Reference Receiver Solutions for SAS-2 Compliance Testing

08-330r3

Kevin Witt
10-2-08

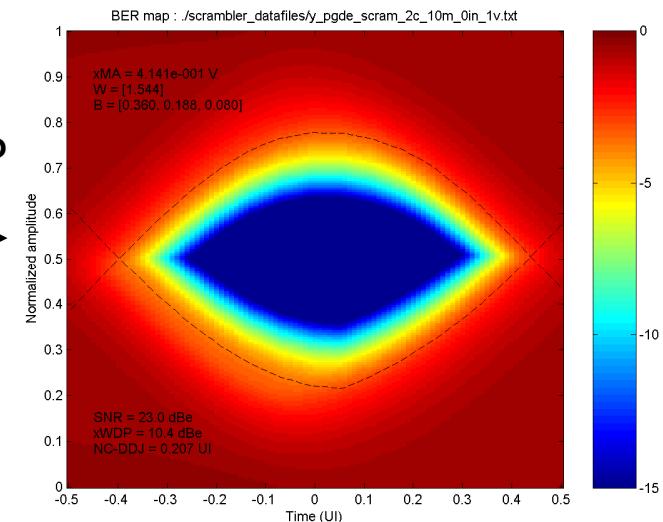
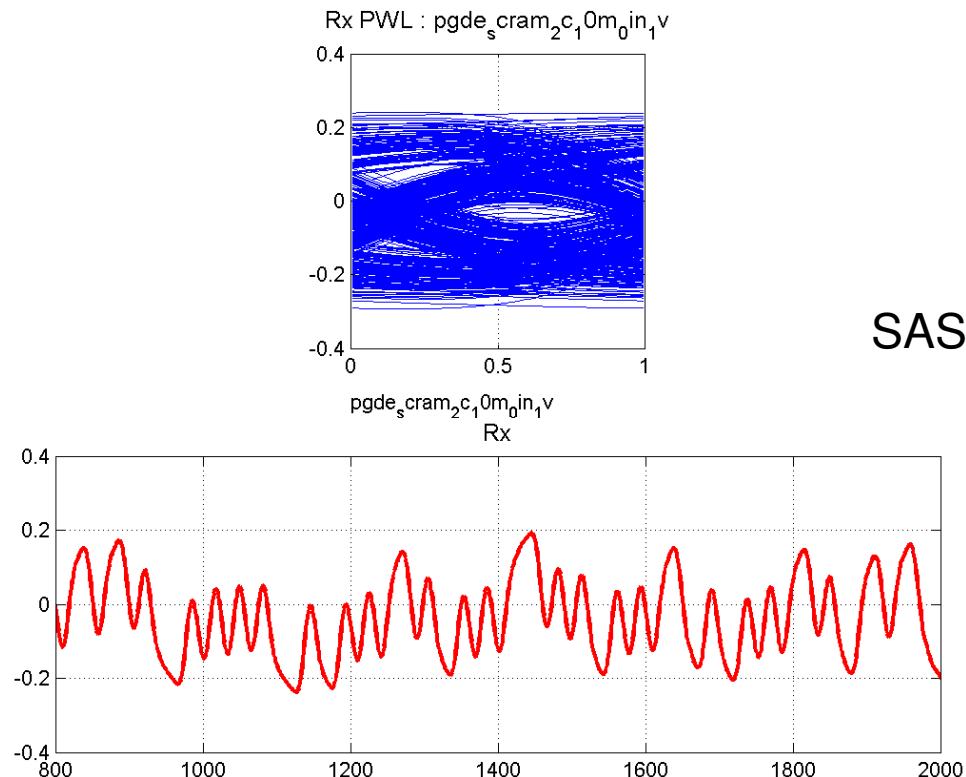
Proposed Changes for Tx Compliance Comment Resolution

1. Remove eye opening specification
2. Add a maximum 13 dBe xWDP
3. Add a maximum 0.4 UI NC-DDJ (TBC)
4. Change Pattern to zero seed scrambler output
5. Add data collection note (h):
 - Collected with zero length test load (5.4.2.2)
 - Sufficient number of averages to minimize RJ
 - Pattern length (2536 bits)
6. Add Post Processing Note (i)
 - Convolve with impulse response of transmitter test load (5.4.2.5)
 - Extract Data bits
 - Process with SASWDP code
7. Add Appendices for SASWDP code
8. Add Appendices for Impulse response
9. ?

zero seed scrambler output

WDP calculation like saswdp

Spec Typo

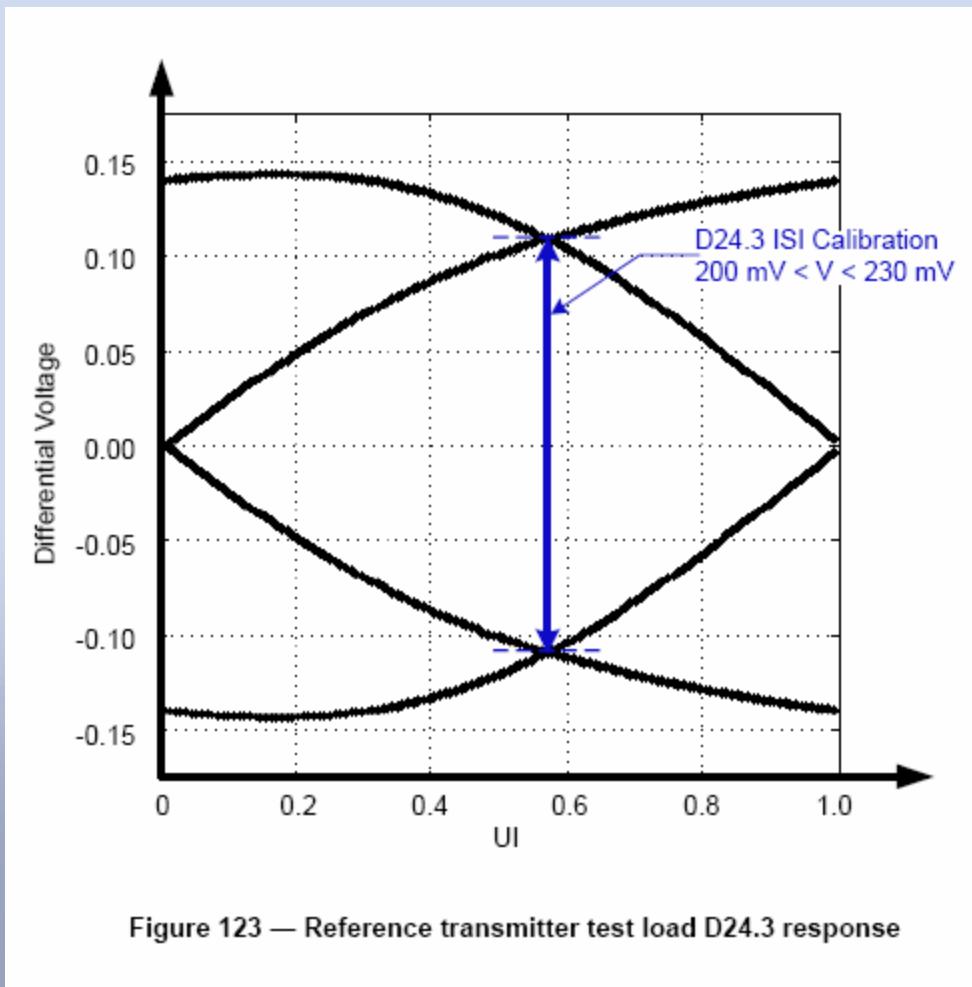
- Figure 123 was not updated to match Table 71

This should be 150 → 190mV
Per: Table 71 in SAS2r14e
